Subject: **WATER AND WASTEWATER CAPACITY AVAILABILITY LETTER**
Flagler SV – DRC Case No. UDP-S22020
501 NE 4th Street, 33301

City of Fort Lauderdale
Public Works Department
Water and Wastewater Capacity Analysis

**Flagler SV – DRC Case No. UDP-S22020
501 NE 4th Street, 33301**

Figure 1 – City Water Atlas

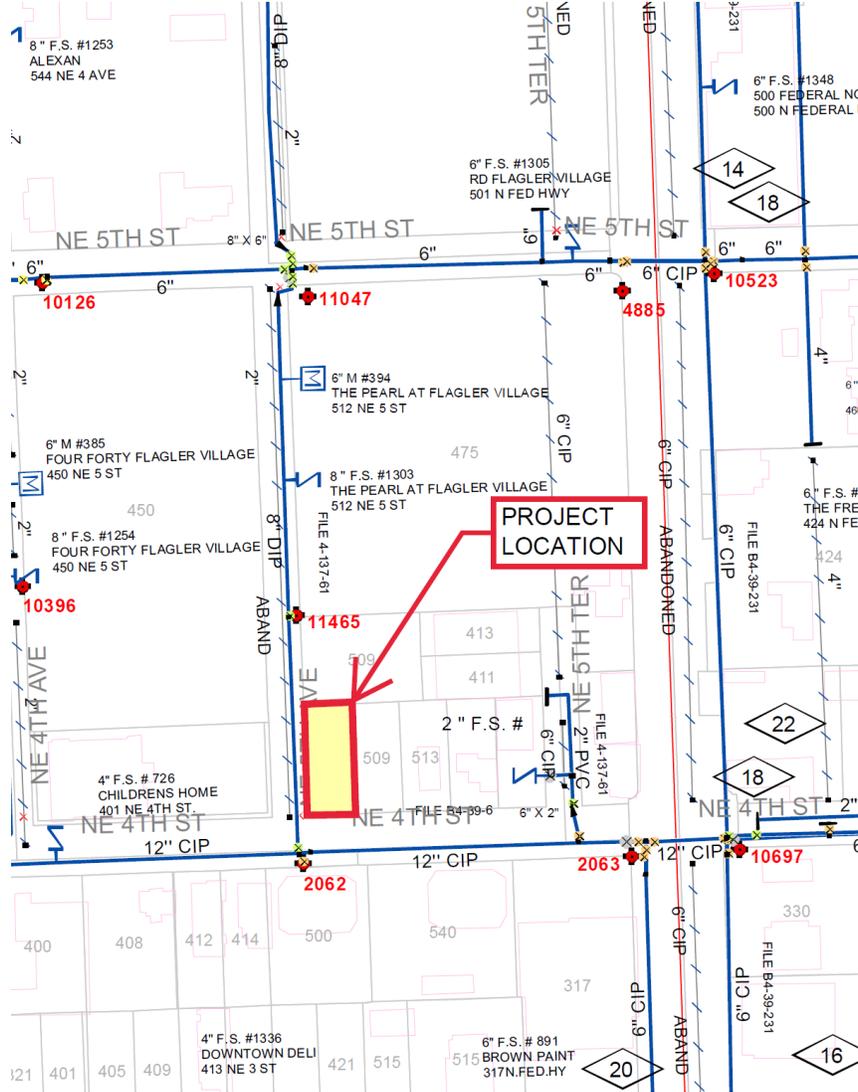
Water: The site is currently served by an 8-inch water main along NE 5th Avenue, west of the project site. See Figure 1.

Evaluation of impact on existing distribution pipe: According to the site plan, the applicant is proposing to utilize the 8-inch water main along NE 5th Avenue. The InfoWater hydraulic model was analyzed to determine the impact of this project on the existing 8-inch water main.

Recommended Water Infrastructure Improvements: No improvements required.

Figure 3

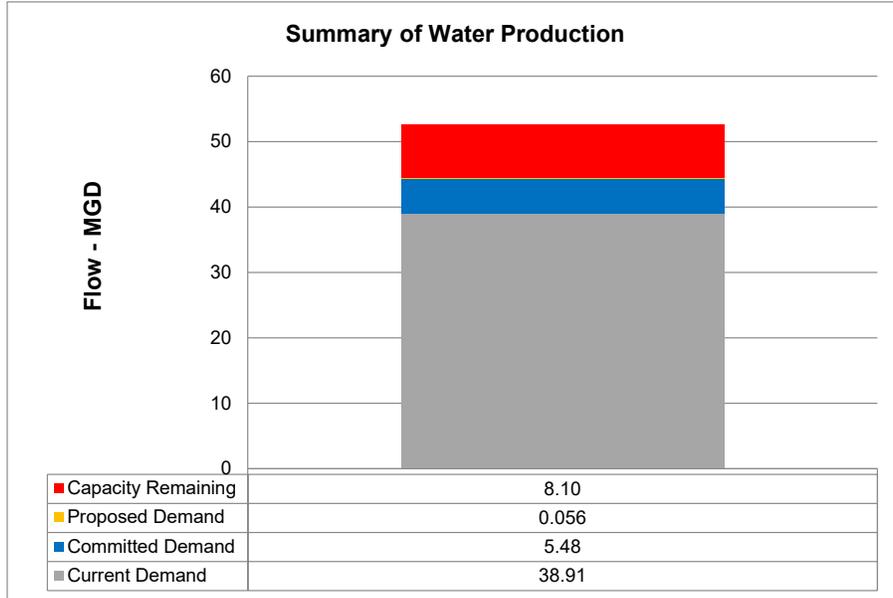
Evaluation of impact of Permitted Water Plant Capacity: The Fiveash and the Peele Dixie Water Treatment Plants are designed to treat 70 MGD and 12 MGD of raw water respectively (82 MGD total). The total permitted Biscayne aquifer water withdrawals for these plants is limited to 52.55 MGD per the South Florida Water Management District (SFWMD) permit number 06-00123-W.

The current twelve-month rolling average production at the two plants is 38.91 MGD. The previously committed demand from development projects in the permitting or the construction stage is 5.48 MGD. Combining these figures with the demand from the proposed project of 0.0561 MGD, the required production would be 44.45 MGD. This is less than the allowable withdrawal limit of 52.55 MGD. Therefore, the water plants have sufficient capacity to serve this project. See Figure 3 below.

Figure 4

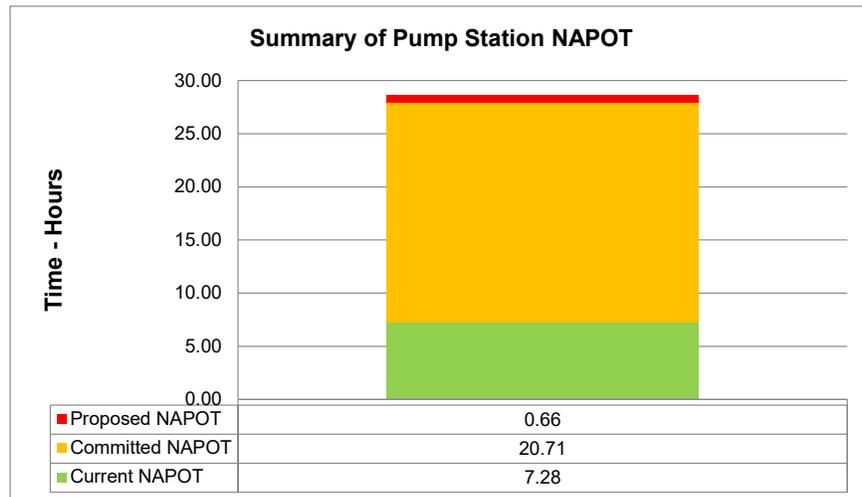
Evaluation of impact on pumping station: PS A-21 has a duty point of 978 gallons per minute (GPM) and has a Nominal Average Pumping Operating Time (NAPOT) of approximately 7.28 hours per day. Based on projected sewage flows, the pumping run times would increase approximately 39 minutes per day. Additionally, there are other committed flows from proposed developments within the PS A-21 basin resulting in 1242.39 minutes of additional runtime. PS A-21 will have a NAPOT of 28.65 hours once the proposed developments are complete, greater than the recommended average of 10 hours per day. See Figure 4 below.

The City's Pump Station Flagler Village A-24 is a major initiative within this basin to reduce the amount of flow handled by the existing PS A-21 and to provide additional capacity within this area. Once PS A-24 is constructed and on-line, there will be sufficient capacity at this new pump station to convey the estimated wastewater demand from the development to the treatment plant.

Recommended Wastewater Infrastructure Improvements: PS A-21 does not currently have sufficient capacity to handle the proposed development. The proposed PS A-24 shall be constructed and put in operation prior to the proposed development seeking a Certificate of Occupancy.

Figure 5

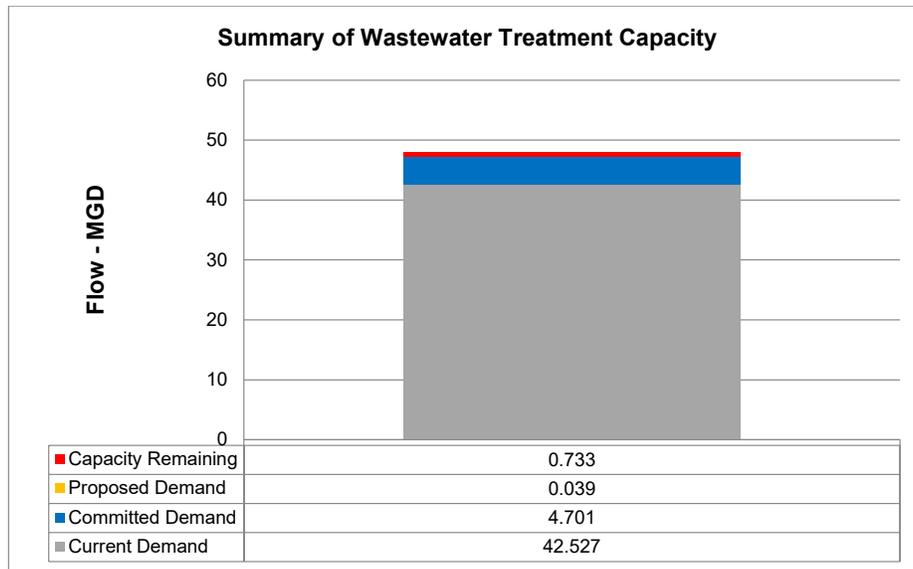
Evaluation of impact of Permitted Wastewater Plant Capacity: The City of Fort Lauderdale owns and operates the George T. Lohmeyer Regional Wastewater Treatment Plant (GTL), which provides wastewater treatment for the City of Fort Lauderdale. The Broward County’s Environmental Protection and Growth Management Department’s (EPGMD) Environmental Licensing & Building Permitting Division’s licensed capacity for GTL is 48 MGD-AADF (Million Gallons per Day – Annual Average Daily Flow). The annual average daily flow (AADF) to the plant is 42.53 MGD. Combining the committed flows for previously approved projects of 4.70 MGD plus the 0.0386 MGD net contribution from the project results in a total projected flow of 47.27 MGD. This is less than the permitted treatment plant capacity of 48 MGD. Therefore, the treatment plant has sufficient capacity to serve this project. See Figure 5 below.
